CITY OF MILWAUKIE

PLANNING COMMISSION

6.1 HR-2024-002 - 1620 SE Waverly Dr.

6.2 HR-2024-003 - 9712 SE Cambridge Ln.

Figure 3. Site plan showing location of proposed footprint expansion (highlighted). Expansion also includes the addition of two lanais (not highlighted).

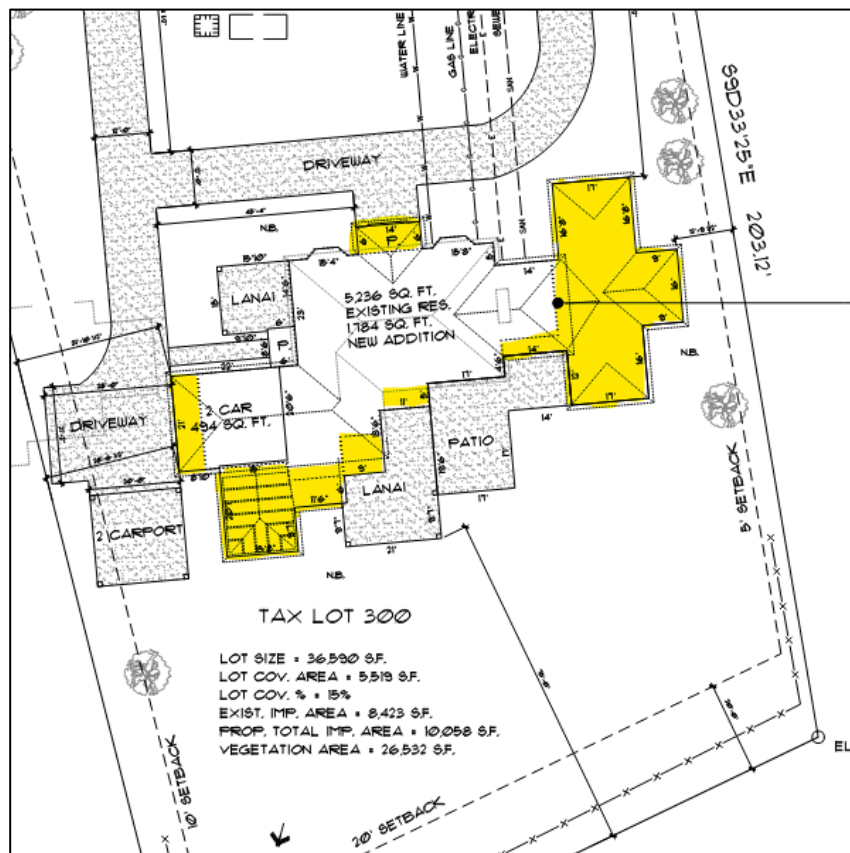
The applicant proposes redesigning various aspects of the north (street-facing) elevation identified as being significant in the 1988 Inventory. Most notably, the plan proposes extending the primary entrance column outward six feet. While the applicant—recognizing the significance of the entryway—is proposing to relocate the distinctive entryway features mentioned in the 1988 Inventory (including the entry door, swan's neck pediment, entablature, and ionic pilasters), the extension of the primary entrance block alters the entryway's original appearance unnecessarily.

The applicant is not proposing a new foundation or to raise or lower the building's permanent elevation. However, the applicant is proposing to make roof alterations on the main block and west wing of the home. These modifications would raise the height of the west wing of the home. Additionally, the proposed northern extension—which is not approvable under Approval Criterion 1: Retention of Original Construction—would raise portions of the main block's roof.

Figure 6. West elevation showing existing facade (bottom) and proposed modifications, including new east wing, lanai, and conservatory (top).

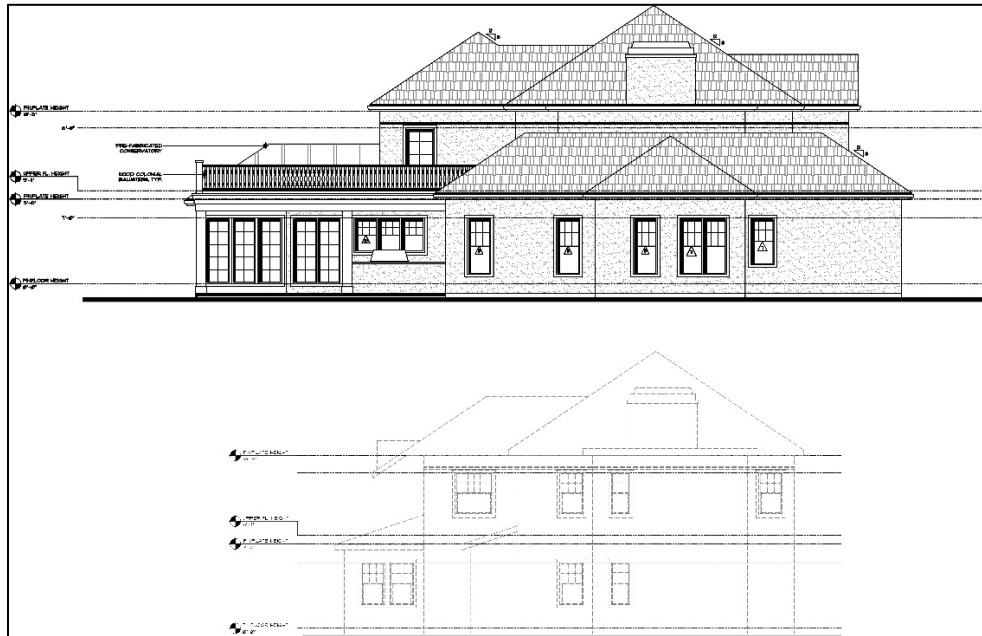
This criterion states that distinguishing qualities defining a resources character shall not be destroyed and that removal or alteration of historic materials shall be avoided. The proposal involves redesigning various aspects of the street facing façade. Most notably, the plan proposes extending the primary entrance column outward six feet which necessarily involves altering high-preservation priority entryway features. Recognizing the significance of the entryway, the applicant is proposing to reuse the distinctive entryway features mentioned in the 1988 Inventory; this includes entry door, swan’s neck pediment, entablature, and ionic pilasters.

The building height criterion states that existing building heights and pitches should be maintained. The applicant is not proposing a new foundation or to raise or lower the building’s permanent maximum height. However, through the central column extension, the proposal would alter the roof design of the main block. The proposal also involves raising the height of the west wing of the home and adding three pediments on the second floor of the west wing that alter the roof’s design. Despite some inconsistencies in the plan set, the applicant proposes retaining the flat roof on the east wing and above the two-story bay windows on the main block.

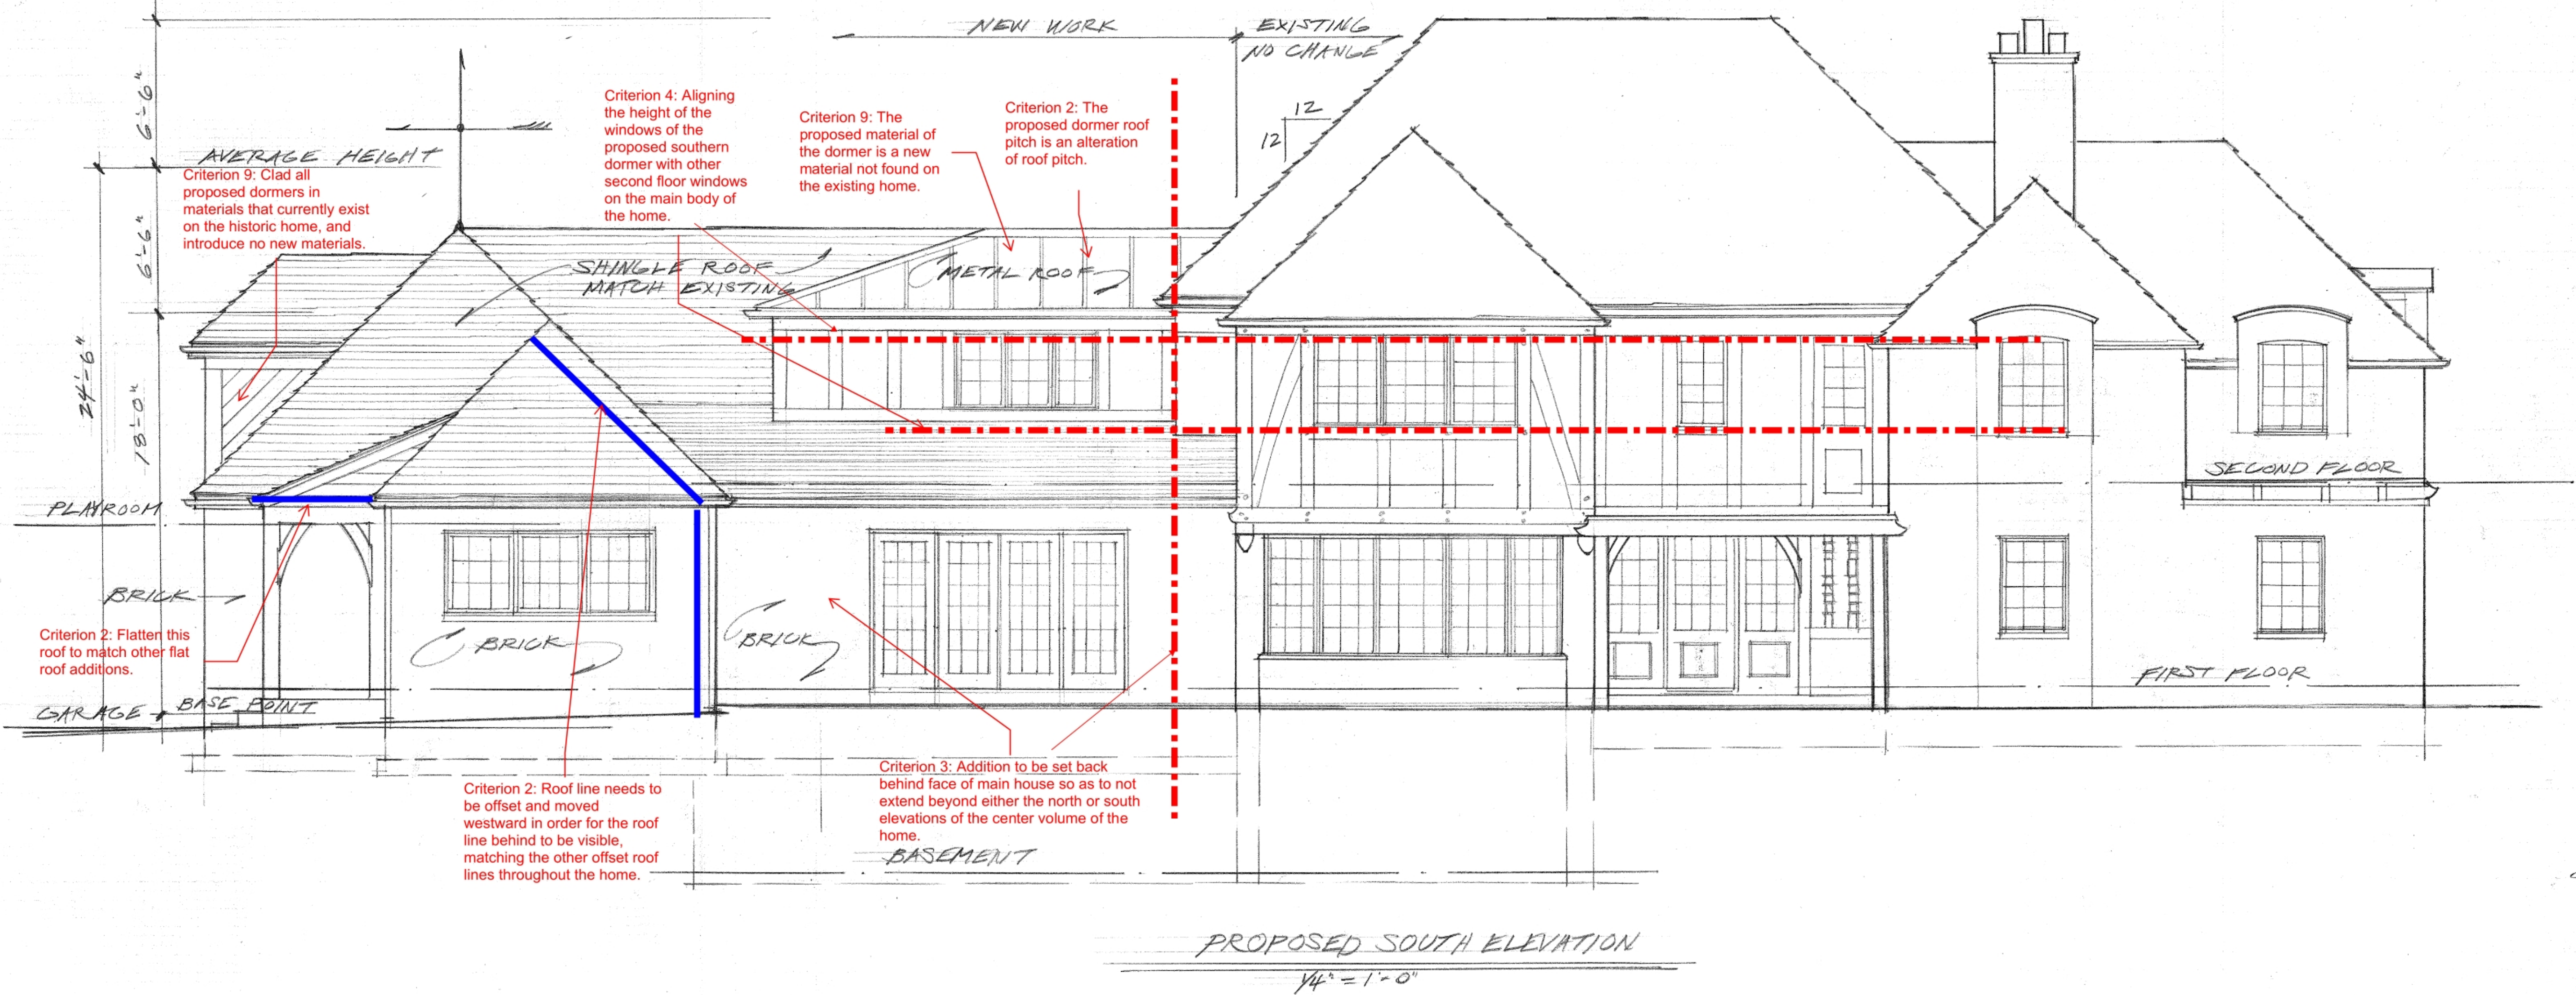
Criterion 2: Flatten this roof to match other flat roof additions.

Criterion 3: Addition to be set back behind face of main house so as to not extend beyond either the north or south elevations of the center volume of the home.
